## Development Review Committee Comments | 4/16/2024 Case PLAT24-0063

Dawn King Addition (6829-6901 Crane Rd)

## WRITTEN STATEMENT OF CONDITIONS

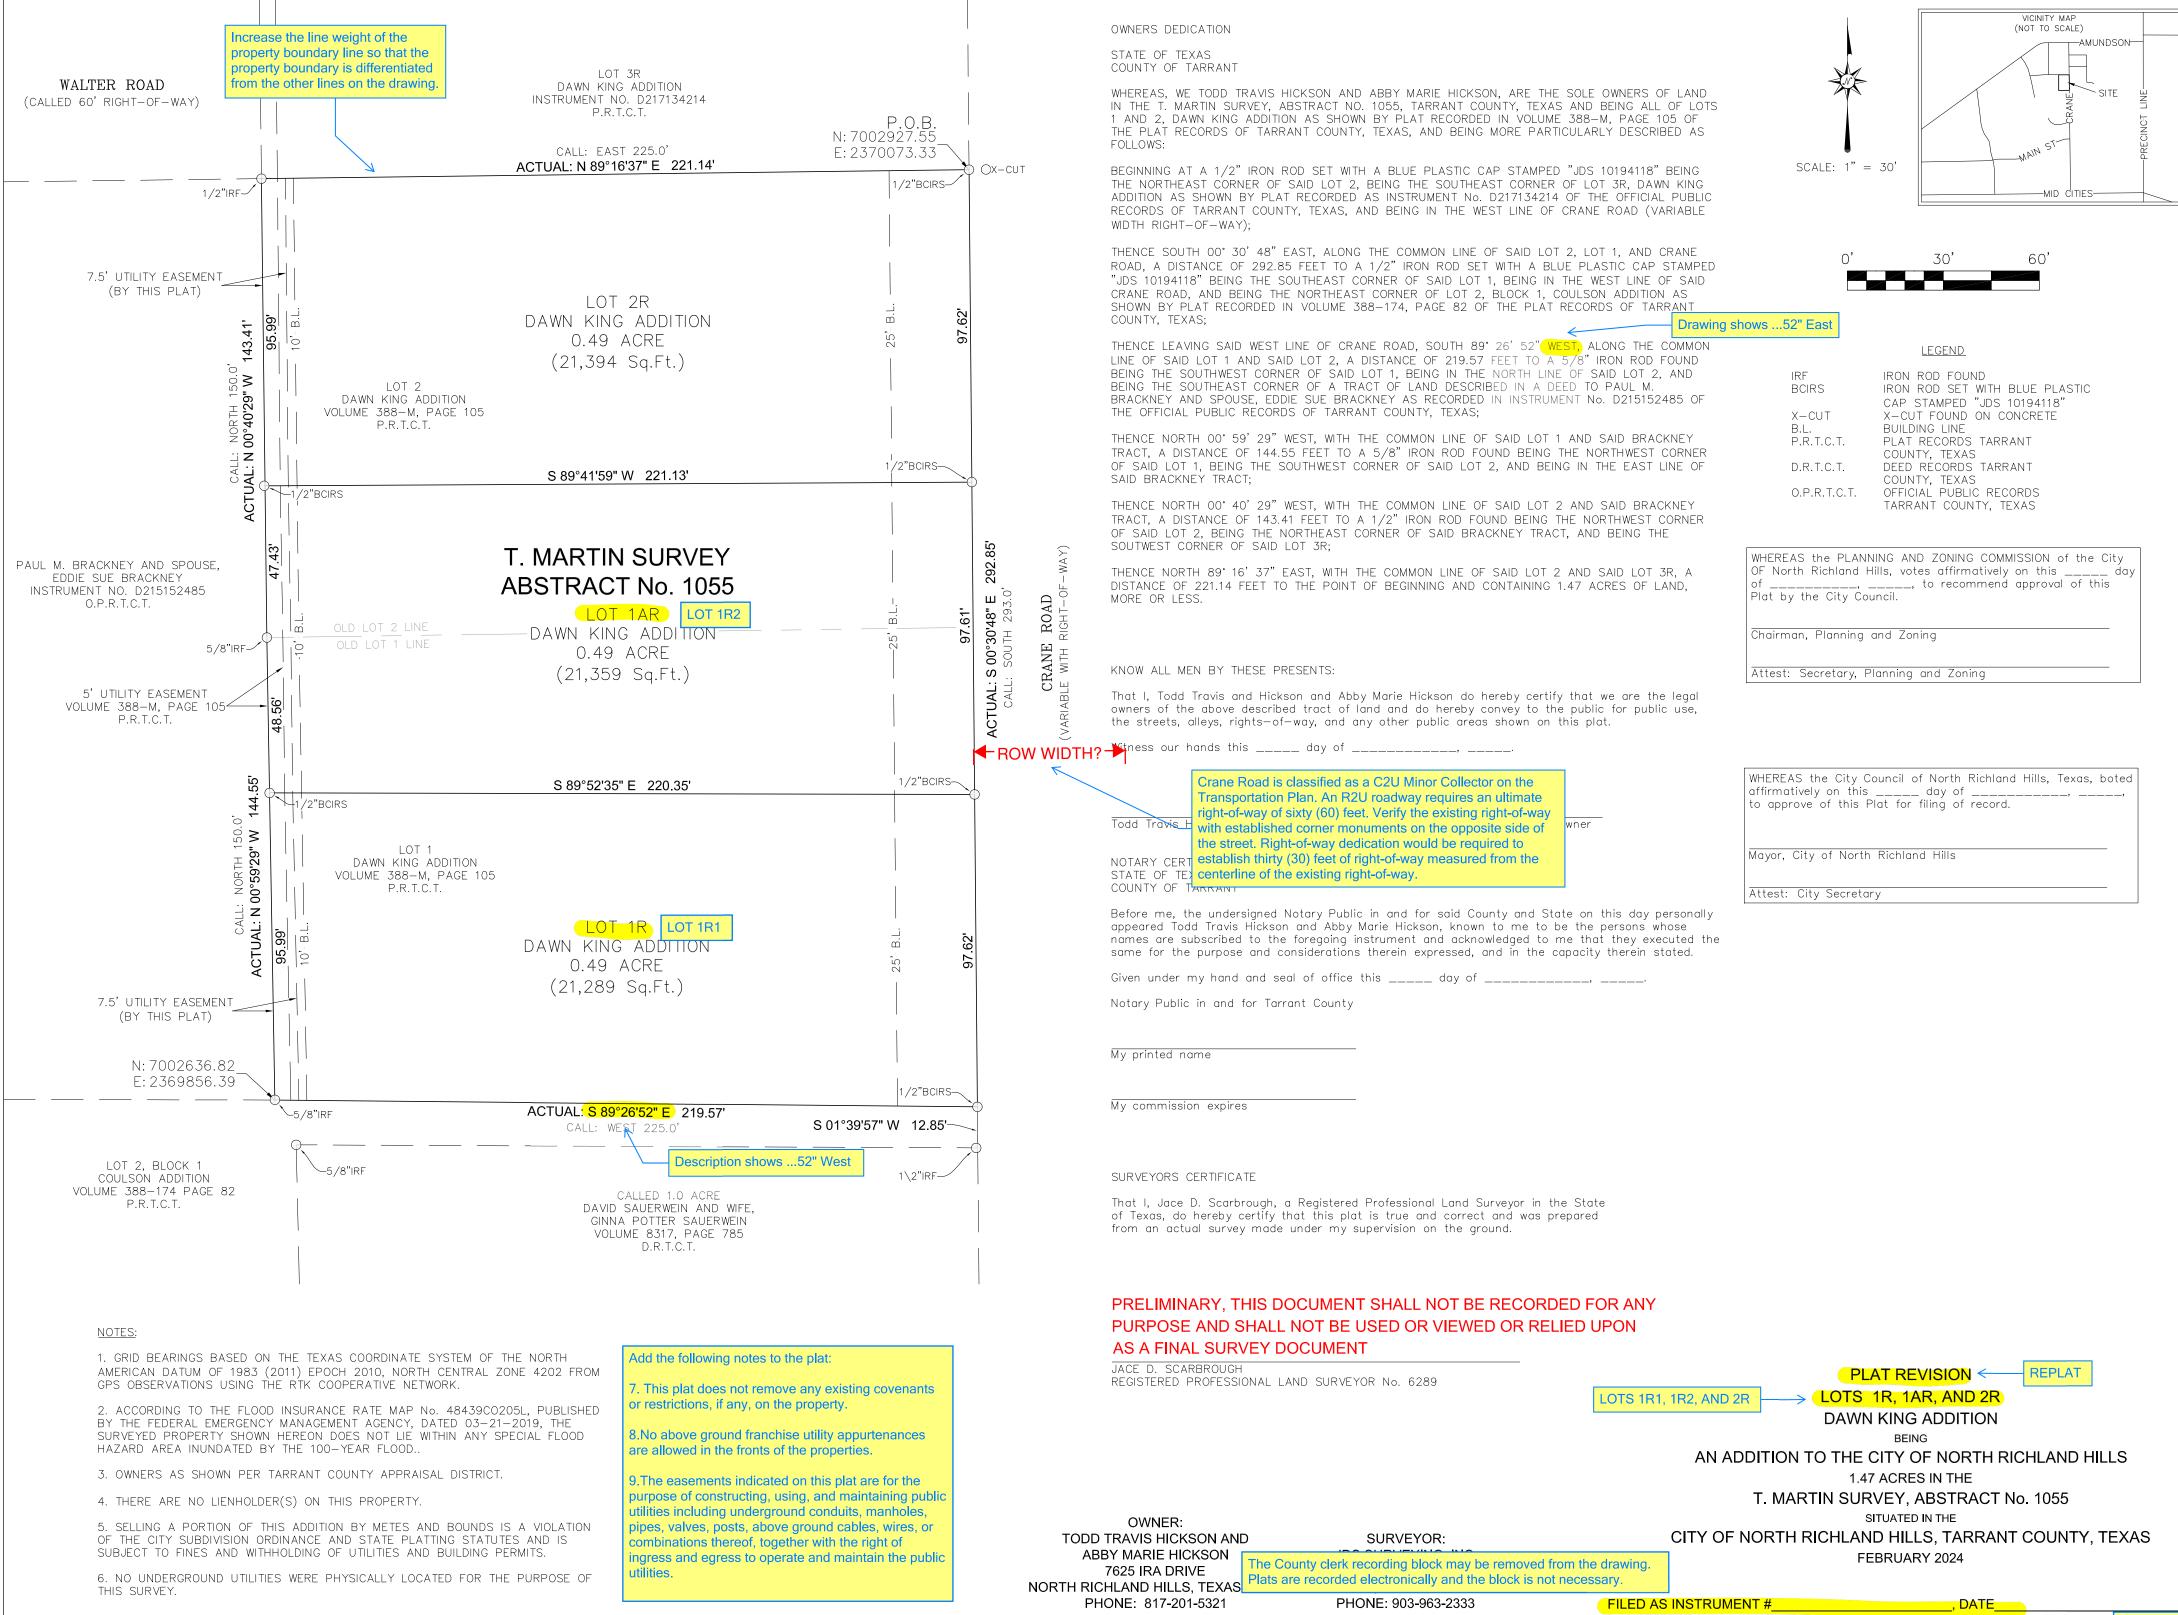
- 2. Update the title block to read REPLAT rather than PLAT REVISION. NRH Subdivision Regulations §110-331 (Requirements for all plat drawings –title block)

- 3. There are minor revisions and corrections required in the owner's certificate, and these are noted on the marked-up copy of the plat. These should be updated as appropriate. NRH Subdivision Regulations §110-331 (Requirements for all plat drawings metes and bounds description)

- 4. Increase the line weight of the property boundary line so that the property boundary is differentiated from the other lines in the drawing. NRH Subdivision Regulations §110-331 (Requirements for all plat drawings subdivision boundary)

- 5. Change the lot designations to Lots 1R1, 1R2, and 2R on the drawing, the title block, and other relevant instances. NRH Subdivision Regulations §110-331 (Requirements for all plat drawings lot and block numbering)

- 6. The County clerk recording block may be removed from the drawing. Plats are recorded electronically, and the block is not necessary. NRH Subdivision Regulations §110-333 (Additional requirements for plat drawings county certification)

- 7. Crane Road is classified as a C2U Minor Collector on the Transportation Plan. An R2U roadway requires an ultimate right-of-way of sixty (60) feet. Verify the existing right-of-way with established corner monuments on the opposite side of the street. Right-of-way dedication would be required to establish thirty (30) feet of right-of-way measured from the centerline of the existing right-of-way. NRH Subdivision Regulations §110-368 (Street right-of-way dedication) and §110-412 (Generally rights-of-way)

- 8. Remove the 10-foot rear building line on the lots. It is not necessary to show this building line as it is regulated by the zoning of the property. NRH Subdivision Regulations §110-331 (Requirements for all plat drawings building setback lines)

- 9. Add the following notes to the plat. NRH Subdivision Regulations §110-331 (Requirements for all plat drawings plat notes and conditions):
  - a. This plat does not remove any existing covenants or restrictions, if any, on the property.

- b. Above ground franchise utility appurtenances are not allowed in the fronts of the properties.
  - c. The easements indicated on this plat are for the purpose of constructing, using, and maintaining public utilities including underground conduits, manholes, pipes, valves, posts, above ground cables, wires, or combinations thereof, together with the right of ingress and egress to operate and maintain the public utilities.

10. Show the property lines and plat recording or deed information of the lots that are within 100 feet of this property on the east side of Crane Road. NRH Subdivision Regulations §110-331 (Requirements for all plat drawings – adjacent properties)
